To: T10 Technical Committee
From: Steven Fairchild, HP (steve.Fairchild@hp.com)
Date: 17 September 2002
Subject: Expander Configuration Details

The purpose for this document is to define the topology addressing details for the edge and fanout expanders. Most of the wording is to clarify existing concepts, with the exception of a new section on configuration of expander route tables within edge and fanout devices.

Figure X – Edge expander device set

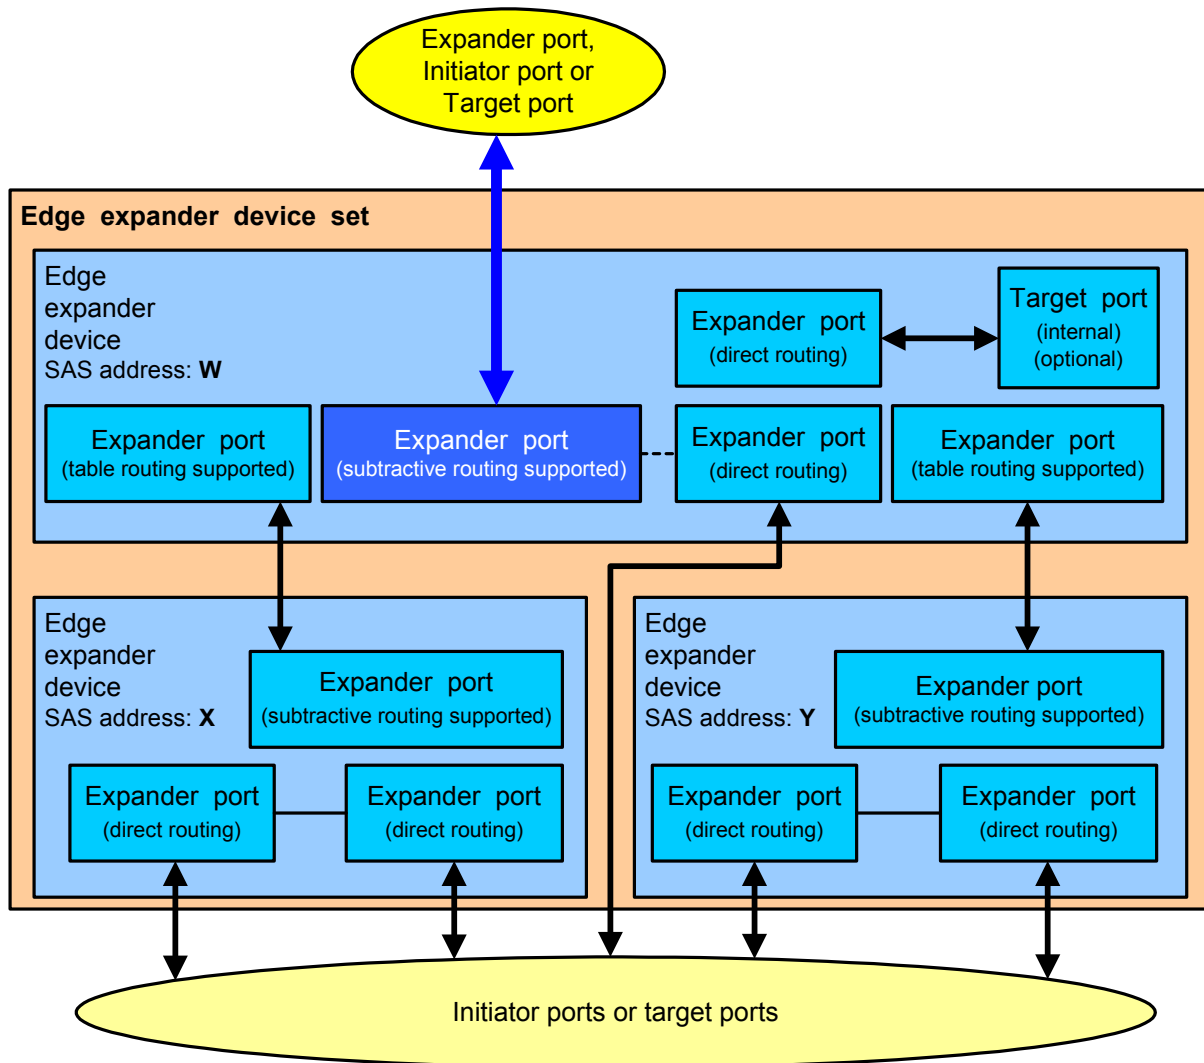
4.1.7.1 Edge expander device set

Edge expander devices may be grouped into edge expander device sets. The edge expander device sets are bounded by the direct routing ports attached to end devices and the port supporting subtractive routing that is: attached to the port of a fanout device; attached to the subtractive routing port on another edge expander device; or attached to an end device.

The table routing ports of an edge expander device provide attachments to other edge expander devices in the edge expander device set.

The number of initiator devices and target devices attached to an edge expander device set may not exceed the maximum number of initiator devices and target devices for an edge expander device (see 4.1.9).

Figure X shows an edge expander device set.

Figure 13 – Maximum expander topology

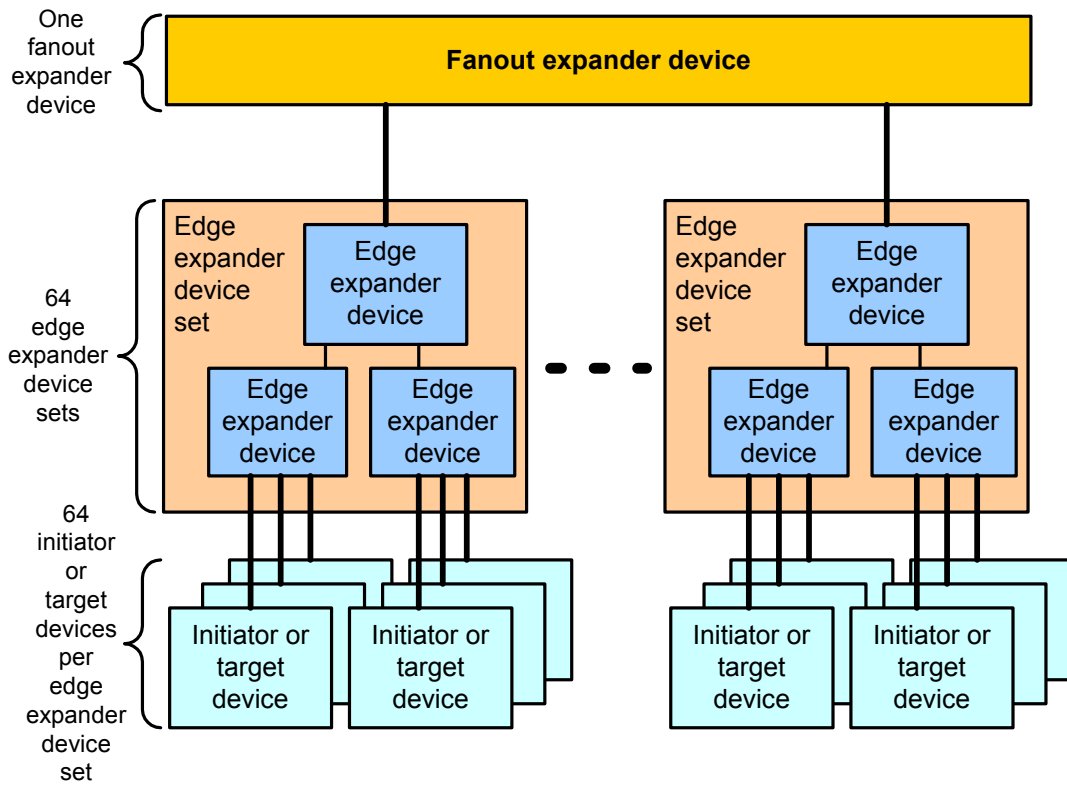
No more than one fanout expander device shall be included in a SAS domain. The fanout expander device may be attached to up to 64 edge expander device sets, initiator devices or target devices.

Each edge expander device set may be attached to no more than one fanout expander device. Each edge expander device set may be attached to up to 64, initiator devices or target devices.

An edge expander device set may be attached to another edge expander device set only if there are no other expanders in the SAS domain.

Figure 13 shows a SAS domain with the maximum number of expander devices.

Figure 14 – Fanout expander topology

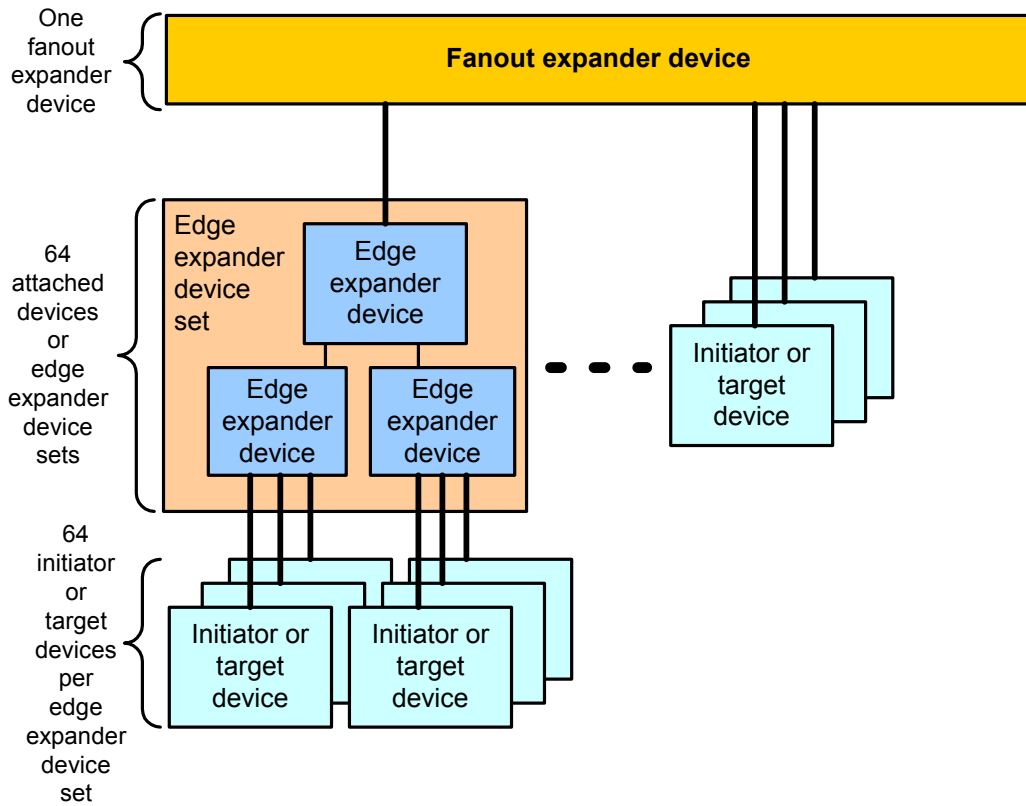
Initiator devices and target devices may be attached directly to the fanout expander device, as shown in figure 14.

Figure 15 – Edge expander device set topology

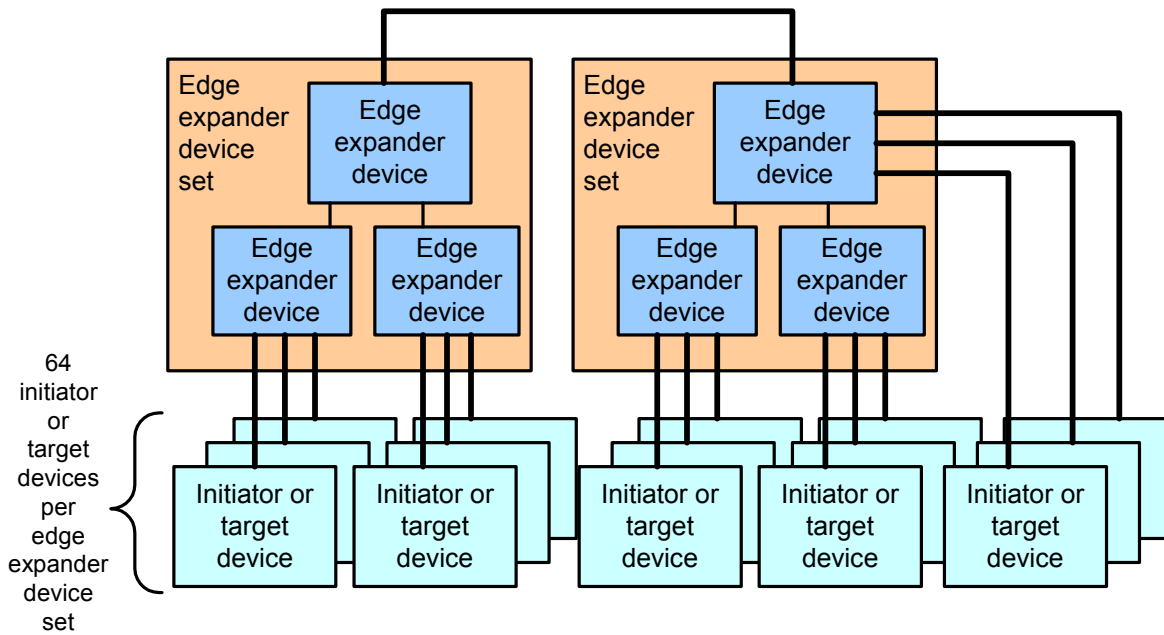
Initiator devices and target devices may be attached to any of the edge expander devices within an edge expander device set and at most, two edge expander device sets may be attached together without a fanout expander, as shown in figure 16.

Figure X – Expander route table example

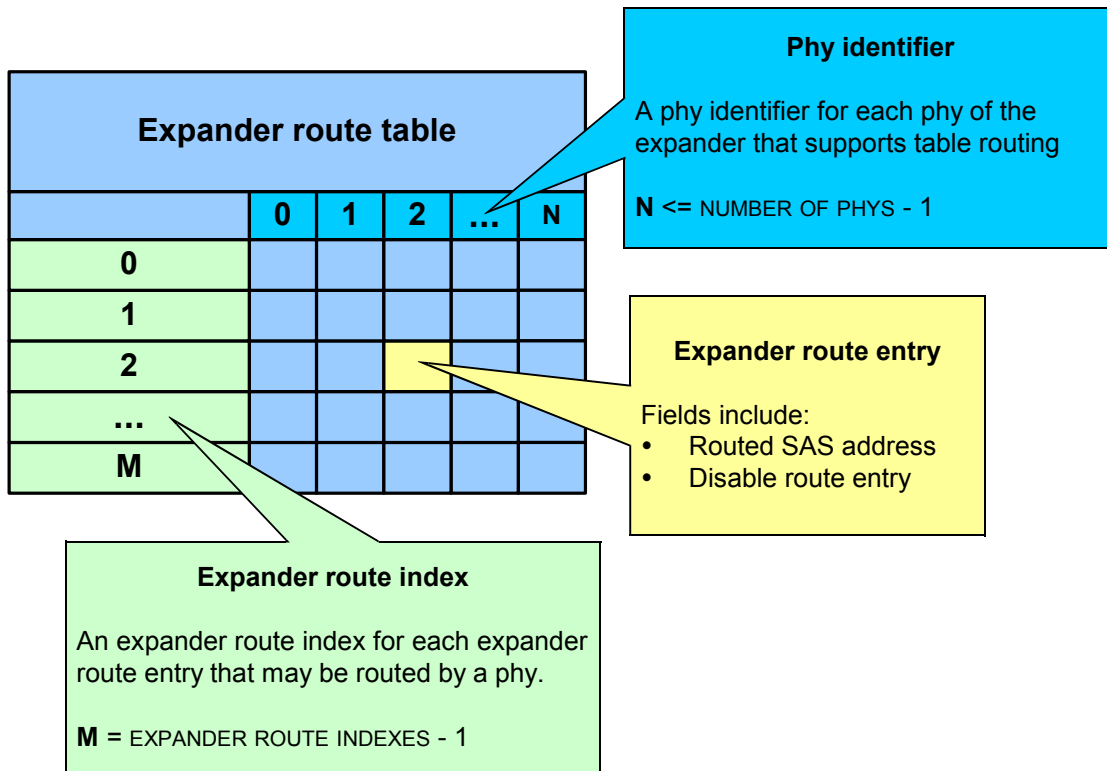
An expander device that supports the table routing method (see 4.1.9.1) shall contain an expander route table. The expander route table is an organized structure that provides an association between destination SAS addresses and expander phy identifiers. Each association is an expander route entry.

An expander device may indicate its capability of maintaining the expander route entries by the CONFIGURABLE ROUTE TABLE field in the SMP REPORT GENERAL response (see 9.4.4.2).

The NUMBER OF PHYS and EXPANDER ROUTE INDEXES fields in the SMP REPORT GENERAL response (see 9.4.4.2) define the size of the expander route table.

An initiator device references a specific expander route entry within an expander route table by using the PHY IDENTIFIER and EXPANDER ROUTE INDEX fields in the SMP REPORT ROUTE INFORMATION (see 9.4.4.5) or SMP CONFIGURE ROUTE INFORMATION (see 9.4.4.9) functions.

Figure X shows a logical representation of an expander route table with the elements identified.

Figure Y – Expander route index order

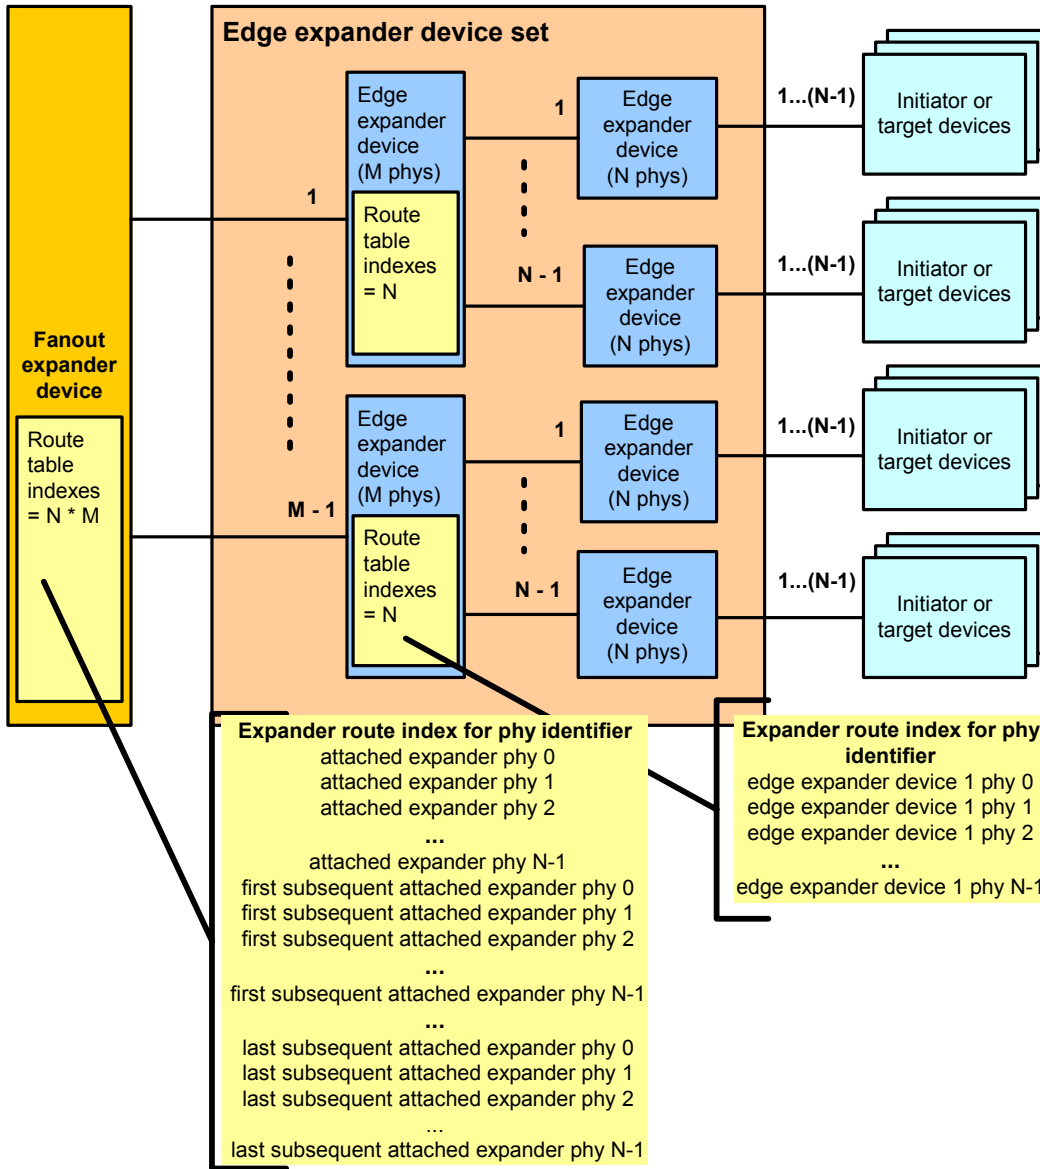
The order of the expander route entries in the expander route indexes is deterministic based on the topology. Figure Y shows the expander route index order.

Figure X – Expander topology example

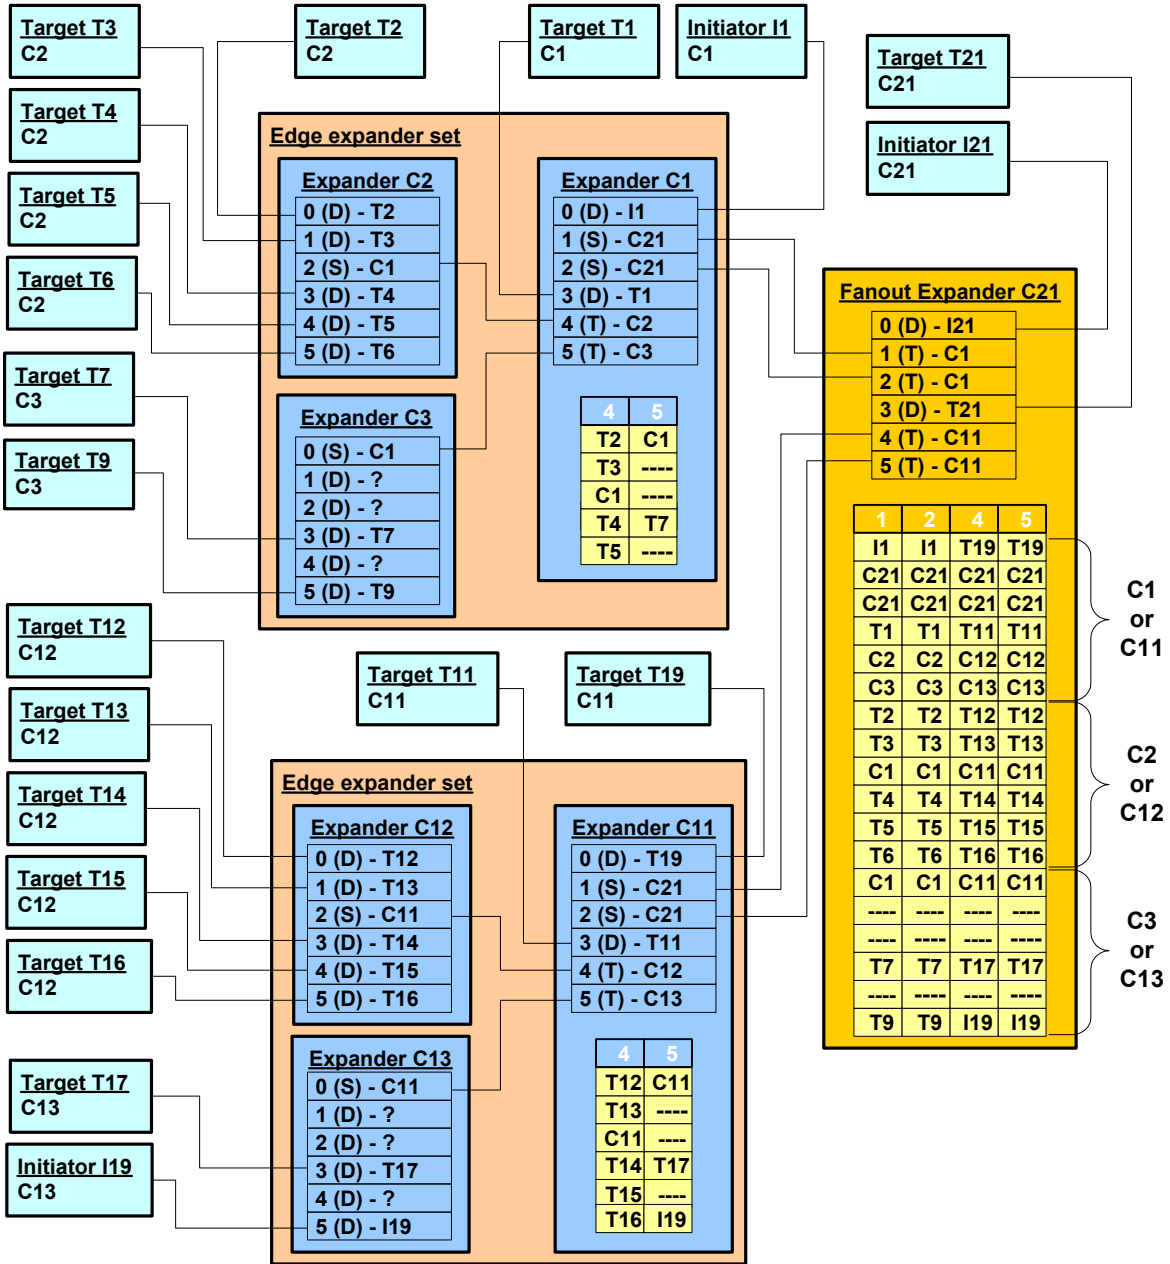
Figure X shows an example topology, which is used to describe the discovery process.

Using Figure X as an example, the application client within initiator device (I1) shall have completed the equivalent of Table X after traversing the edge expander device set with edge expander device members, C1, C2 and C3.

Using Figure X as an example, the initiator device (I21) shall have completed the equivalent of Table Y after traversing the fanout expander (C21) and encountering the configurable edge expander device sets (C1, C2, C3 and C11, C12, C13).
